Work Order ID 92353

Item Name: Replacement Skidtube

DRAWING NO. D2580	TITLE 205 SKIDTUBE ASSEMBLY	REV. E	DART AEROSPACE LTD ENGINEERING ORDER		D.E.O. NO. D2580-E-1	SHEET NO. SHEET 1 OF 1	SCALE NTS
DRAWN UP	CHECKED ASS	MFG. APPR. ER	APPROVED H	DE APPR. H			
DATE 11.12.13	DATE 11.12.13	DATE 11.12.13	DATE 11.12.13	DATE 11.12.13

CHANGE ALL C'BORED WELDED CROSSBOLT SPACERS TO SWAGED SPACERS

SECTION B-B D5-2
SCALE 5X

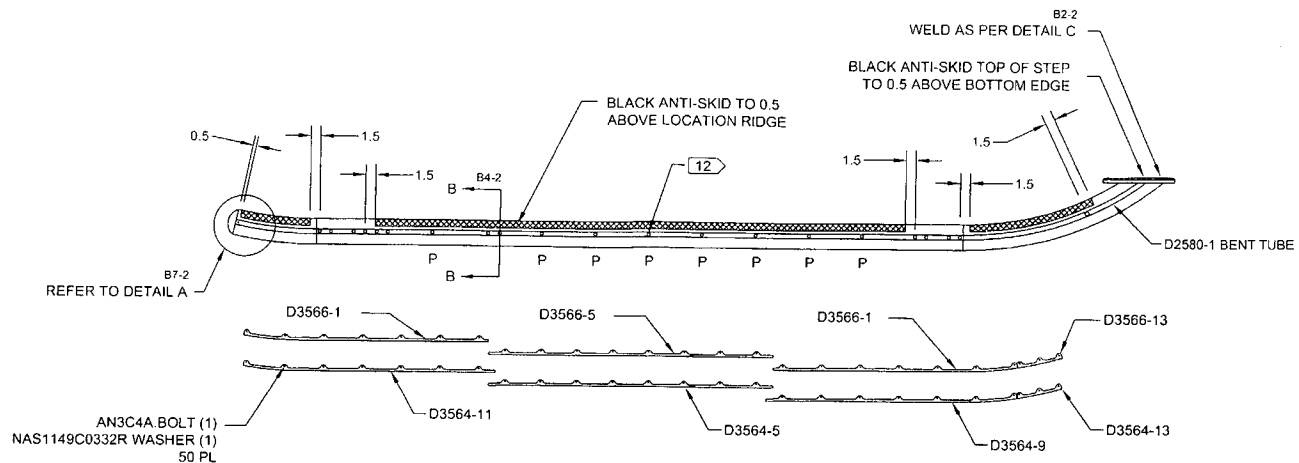
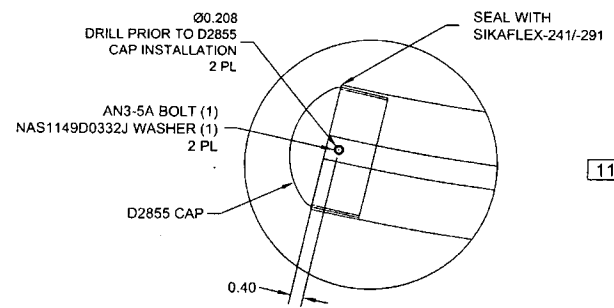
SECTION B-B, SECTION F-F, & SECTION I-I ARE AMENDED AS FOLLOWS
FOR ALL HOLES THAT WERE ORIGINALLY C'BORED:

AFTER DRILLING AND BENDING ASSEMBLY
PERFORM THE FOLLOWING FOR Ø0.508 HOLES ONLY:

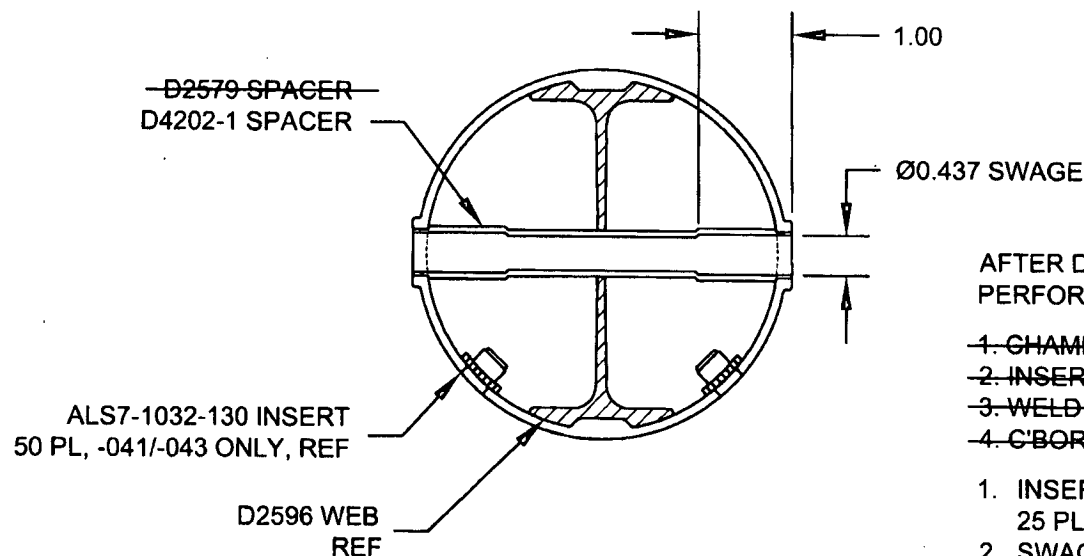
WAS

WELD 4X D2579 SPACERS PER DWG
IN LOCATIONS MARKED "NO C'BORE".
REF SHEET 4 OF DWG.
